Access Compliance Report

Public Rights-of-Way

(Curb Ramps)

Intersection ID: 52226	Main Street: AMESBURY_HILL_DR	Cross Street: AUBURN_HILL_LN	Location: NW
ADA ID: F1DF5E254569	Ramp Type: Perp	Initial Pass/Fail: Fail	Overall Compliance: No
		Severity Score: 10

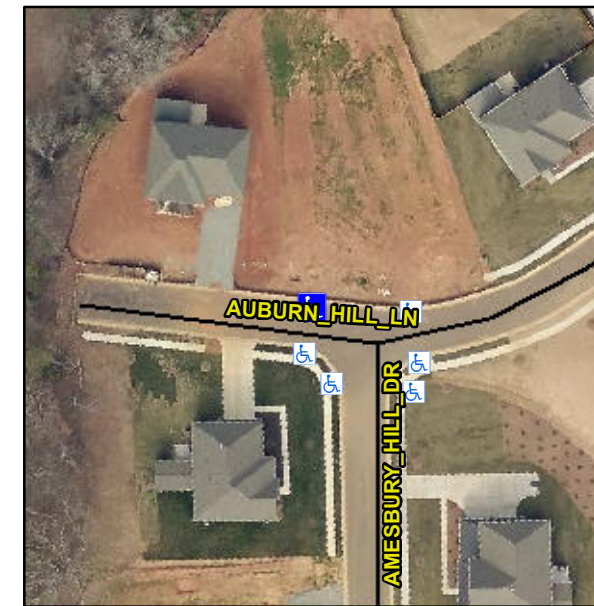
Not Found, R304.5.1

Compliance	Description	Data	Compliance	Description	Data
N/A	Ramp Length (in)	48.0	Yes	Ramp Slope (%)	5.4
No	Ramp Width (in)	47.0	Yes	Ramp XSlope (%)	4.7
N/A	Flare Type LT	N/A	N/A	Flare Type RT	N/A
N/A	Flare Slope LT (%)	N/A	N/A	Flare Slope RT (%)	N/A
N/A	Flare Traversable LT?	N/A	N/A	Flare Traversable RT?	N/A
N/A	Landing Length (in)	N/A	N/A	DWS Provided?	N/A
N/A	Landing Width (in)	N/A	N/A	DWS Contrast?	N/A
N/A	Landing Slope (%)	N/A	N/A	DWS Length (in)	N/A
N/A	Landing X Slope (%)	N/A	N/A	DWS Full Width?	N/A
N/A	Landing Curb? (Y/N)	N/A	N/A	DWS Offset (in)	N/A
N/A	Shared Landing?	N/A			
N/A	Gutter Ponding?	N/A	N/A	Gutter Slope (%)	N/A
N/A	Gutter Lip Ht (in)	N/A	N/A	Gutter X Slope (%)	N/A
N/A	Painted X Walk1?	No	N/A	Painted X Walk2?	N/A
	X Walk 1 Direction	To S		X Walk 2 Direction	N/A
N/A	X Walk 1 Width (in)	N/A	N/A	X Walk 2 Width (in)	N/A
	X Walk 1 Slope (%)	0.7		X Walk 2 Slope (%)	N/A
	X Walk 1 X Slope (%)	6.2		X Walk 2 X Slope (%)	N/A

Remove & Replace Entire Ramp.
